Proposal for amendments to UN Regulation No. 46

The text reproduced below has been prepared by the expert from Germany for the first meeting of the second phase of the informal group on camera-monitor-systems (IG CMS-II) to introduce provisions for camera-monitor-systems to be used as devices for indirect vision.

The document is a consolidated version of **UN-R 46/04** including proposed amendments from document **ECE/TRANS/WP.29/GRSG/2011/23/Rev.1**. Additional provisions for camera-monitor-systems were added in a new annex.

Regulation No. 46

Figure A

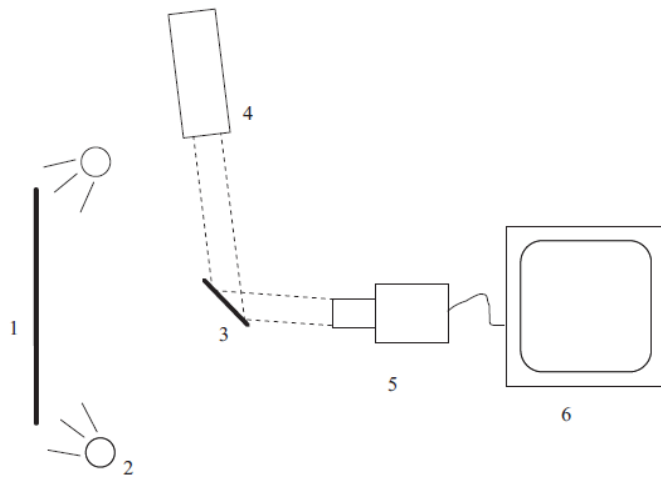
6.2.2.2.1.4. An example of the set-up is given in the figure A below.

Figure 5

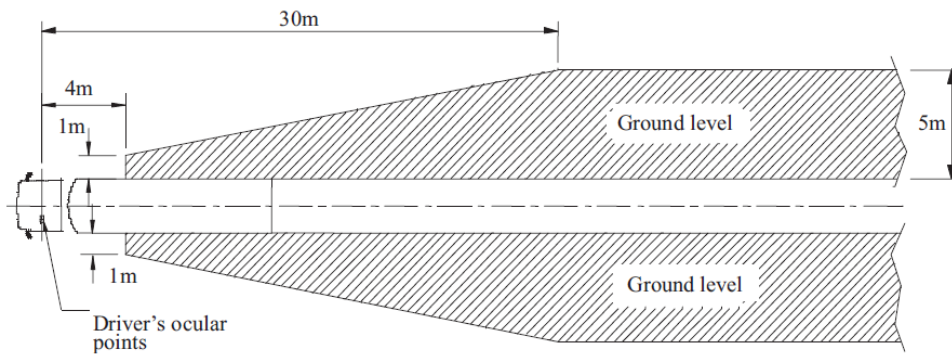
Field of vision of Class II mirrors
Class II field of vision

Figure 7

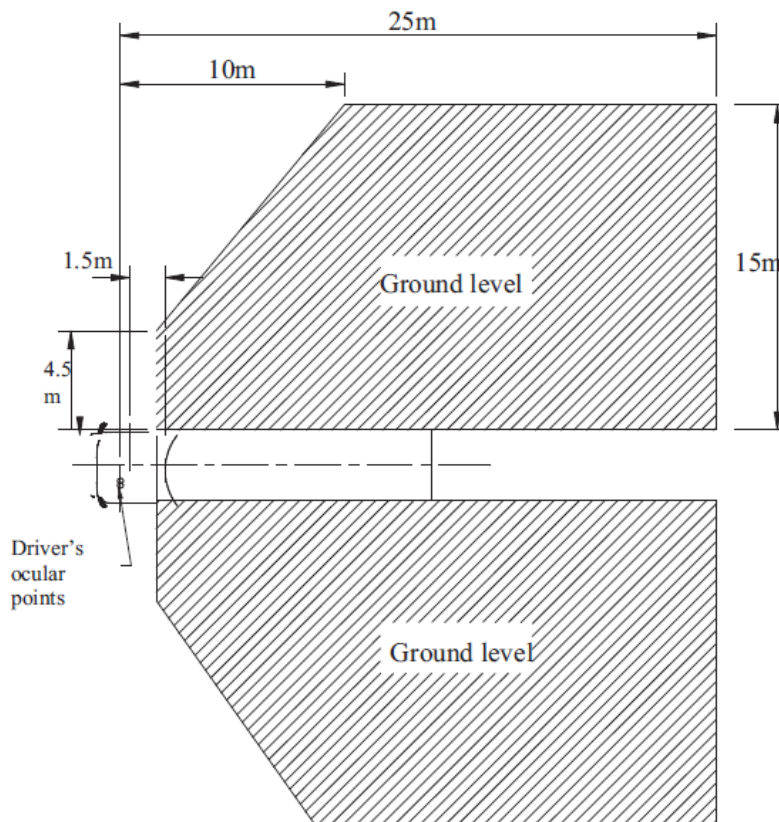
~~Field of vision of Class IV wide-angle mirrors~~
Class IV field of vision

Figure 9

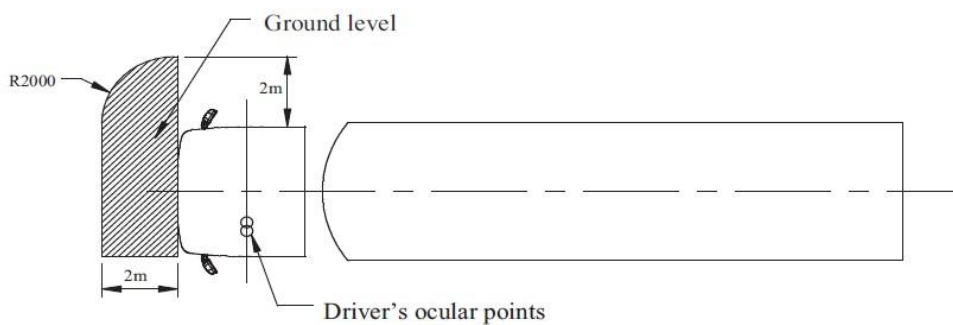
~~Field of vision of Class VI front mirror~~
Class VI field of vision

Figure 10

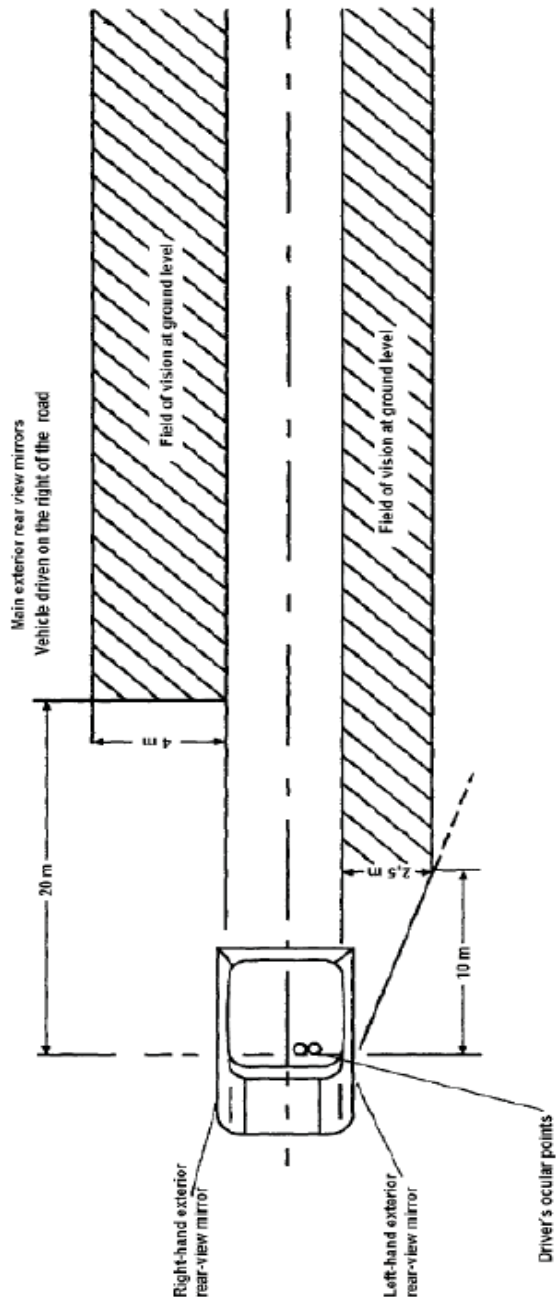
Field of vision of Class VII mirrors
Class VII field of vision mirrors
